**RESPONSIVENESS SUMMARY  
FOR THE  
PROPOSED REMEDIAL ACTION PLAN  
AT THE  
MEDLEY FARM SUPERFUND SITE  
GAFFNEY, SOUTH CAROLINA**

Public Comment:  
February 13 through April 14, 1991

May 1991

Prepared for:  
U.S. Environmental Protection Agency  
Region IV

FIGURE 4.2  
APPROXIMATE EXTENT OF  
SOURCE AREAS EXCEEDING  
CALCULATED SOIL REMEDIATION  
LEVELS  
MEDLEY FARM SITE

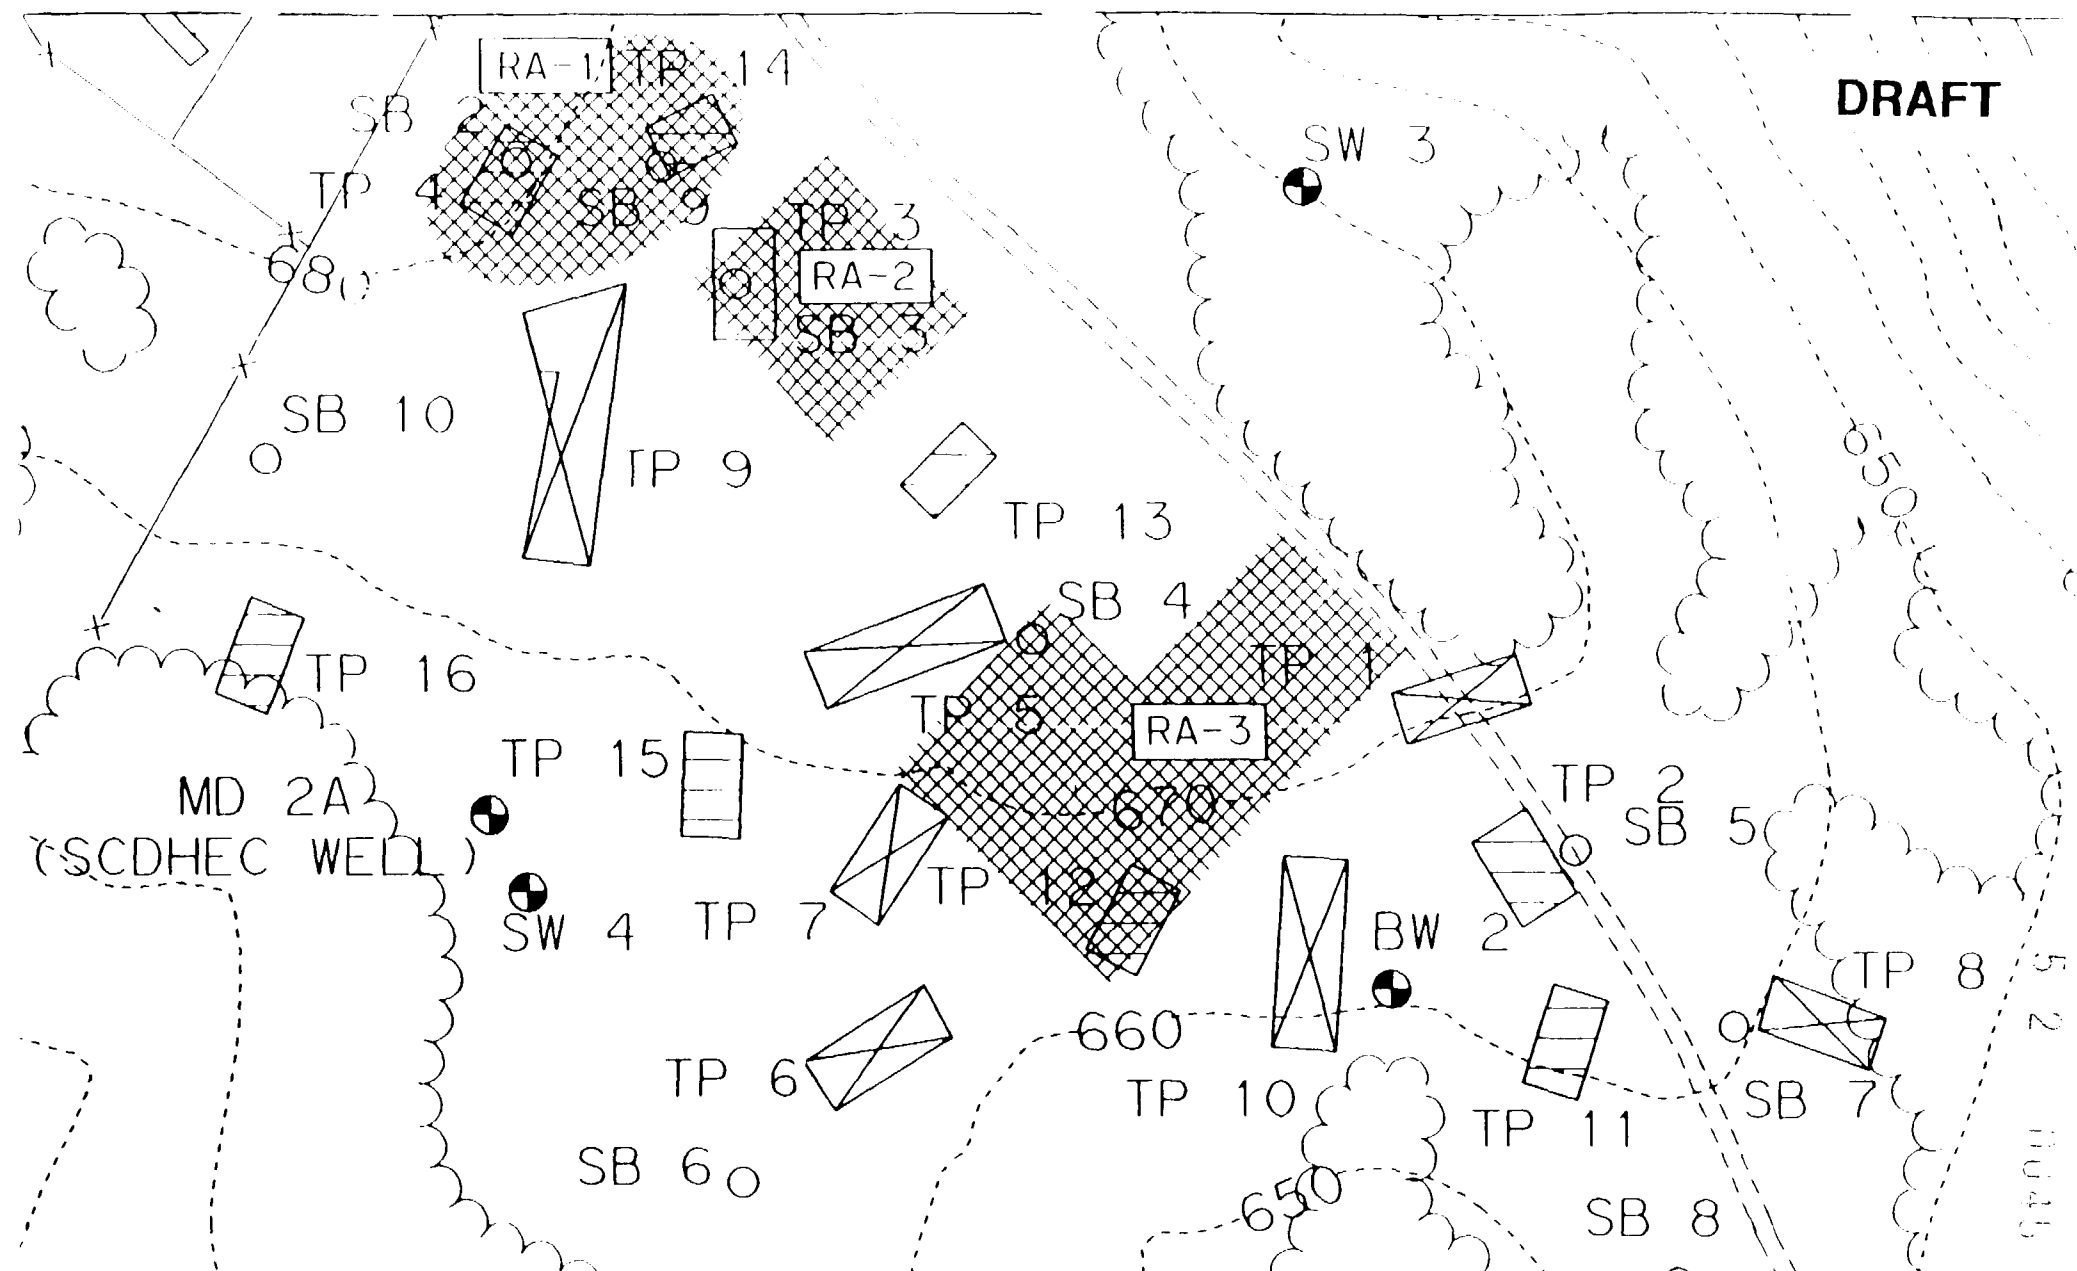
- o They question the necessity of source control measures, since the Baseline Risk Assessment indicates that Site soil contaminants do not pose a direct risk. In addition, they point out that recent EPA and other technical documents conclude that the time frames for aquifer remediation are underestimated, and that true time frames will in fact always exceed those made using models. The PRPs believe that SVE will not shorten the estimated time required to remediate Site groundwater to MCLs.
- o A cost comparison between SVE with a pump-and-treat system, and natural flushing with pump-and-treat, led the PRPs to conclude that natural flushing was a more cost-effective remedy.

The Agency agrees that levels of contaminants across parts of the Site are less than 1 milligram per kilogram (mg/kg). However, the Feasibility Study (FS) proposed installing the SVE system in those areas of the Site where elevated levels of contaminants in the soils were encountered. These areas are defined in Figure 4.2 of the Feasibility Study.
